Subject: Collin County Healthcare Facility, Parking Garage, and Medical Examiners
PCO No. 137; RFI #451 PG Overhead Coiling Door Conflicts North and South

224057- Collin County Public Health Buildings
2300 Bloomdale Rd
McKinney, TX 75071

RFI #451: PG - Overhead Door / Coiling Door Installation Conflict

DOOR L01A

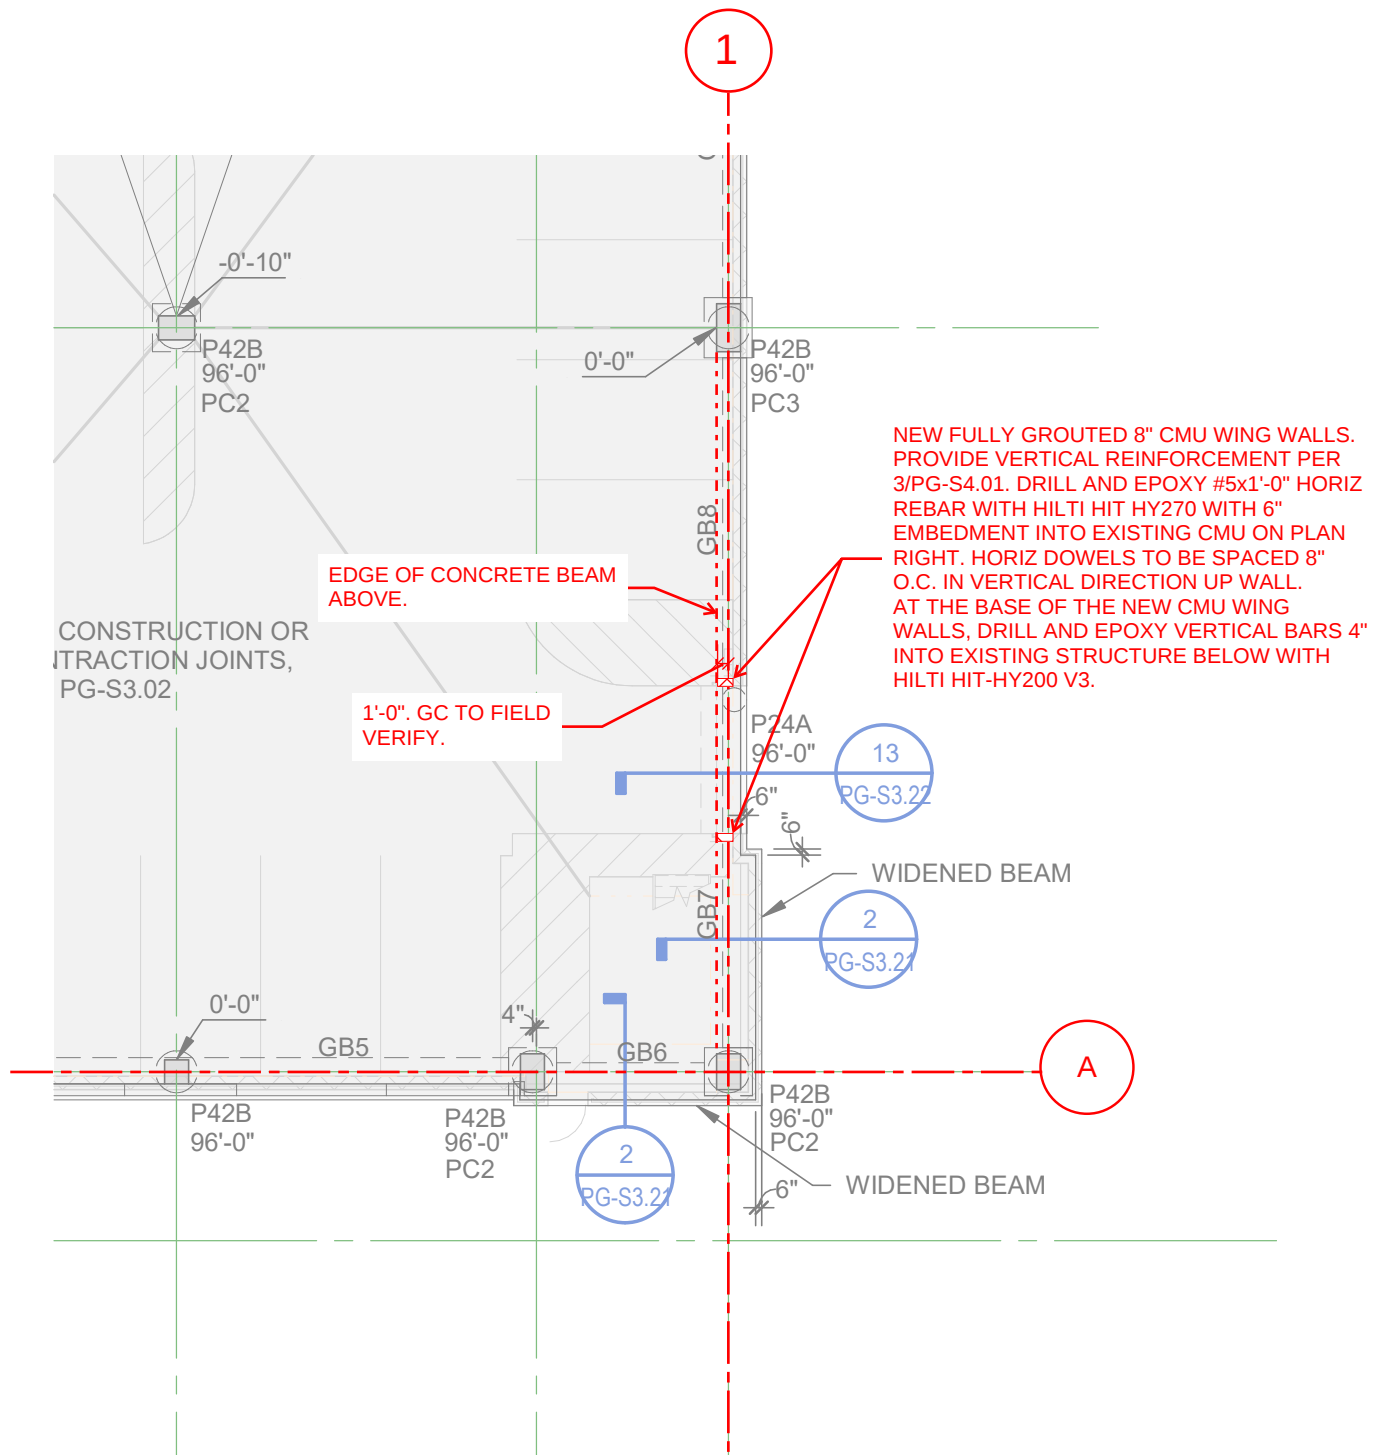
SEE ATTACHED RESPONSES FOR DOORS L01A, L01B AND 100A ONLY. ALL STEEL SHALL BE HOT-DIPPED GALVANIZED. GC TO SCAN EXISTING CONCRETE TO ENSURE NO CONFLICTS WITH REBAR AND PT.

DOOR 100A

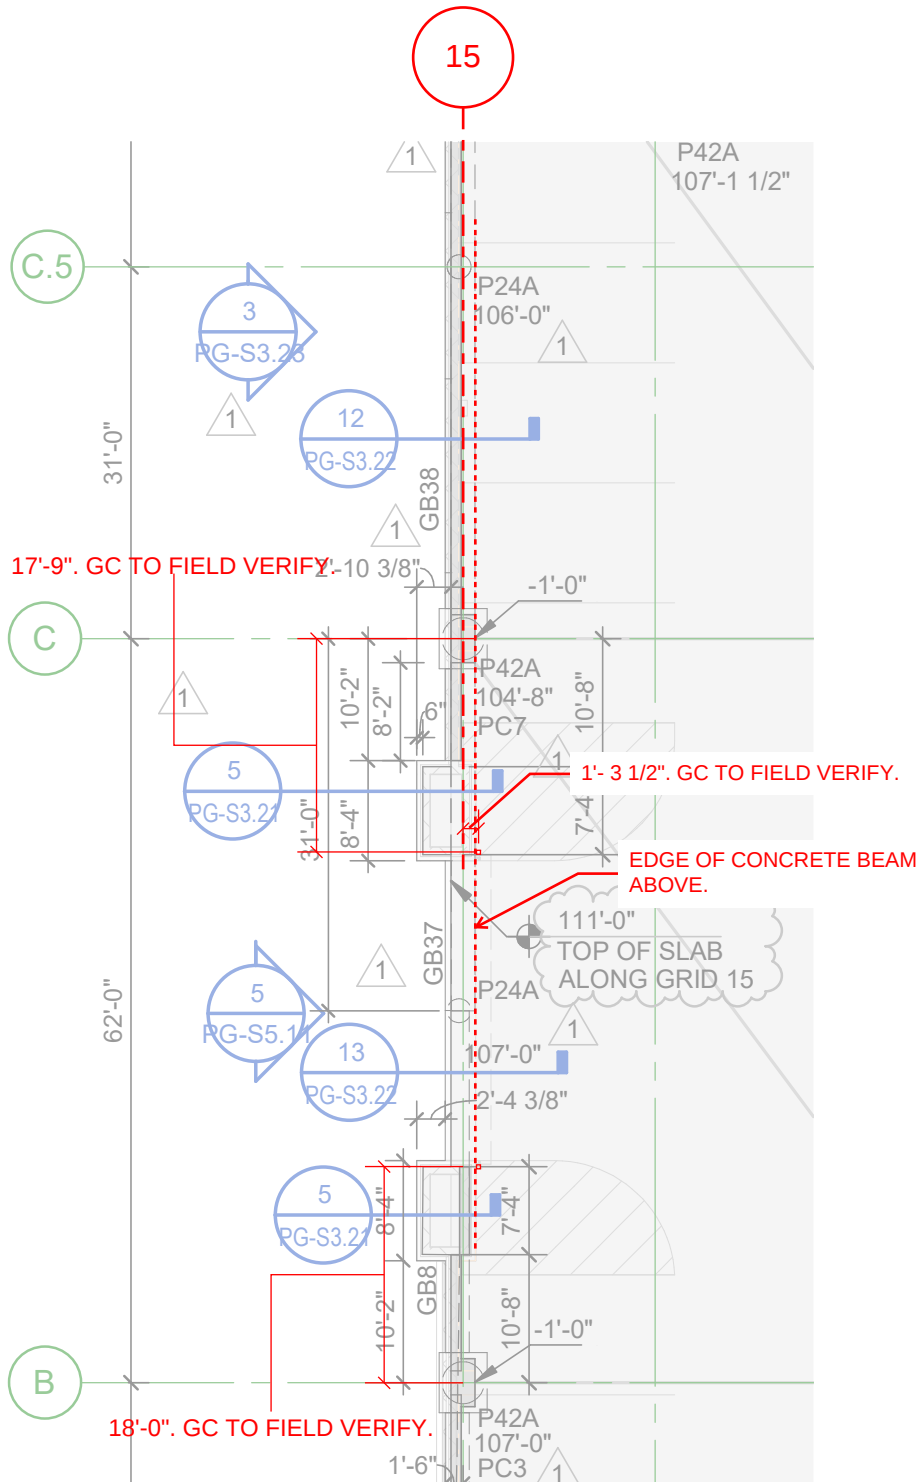
1. POST SIZE AND CONNECTION DETAILS SIMILAR TO DOOR L01B. SEE PAGE 9 FOR POST TOP CONNECTION.

POST TOP CONNECTION TO CONCRETE

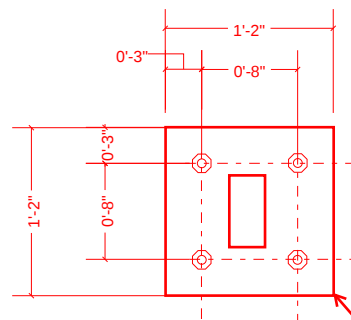
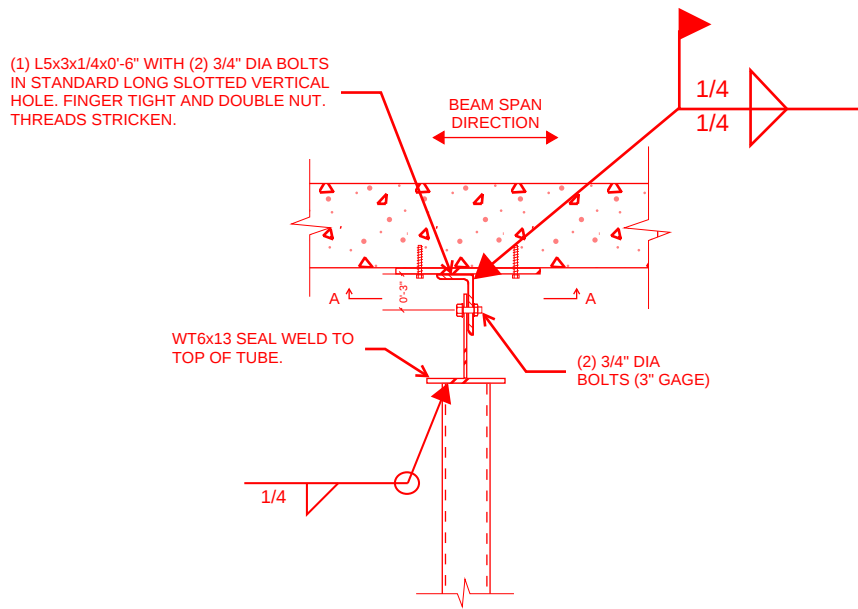
PL1/2X14X1'-2" W(4) 1/2" DIA HILTI KWIK HUS-EZ (KH-EZ)-SS316 WITH 2" EMBEDMENT INTO EXISTING CONCRETE. ACCEPTABLE TO SHIFT CONNECTION PROFILE WITHIN PLATE AS NEEDED.
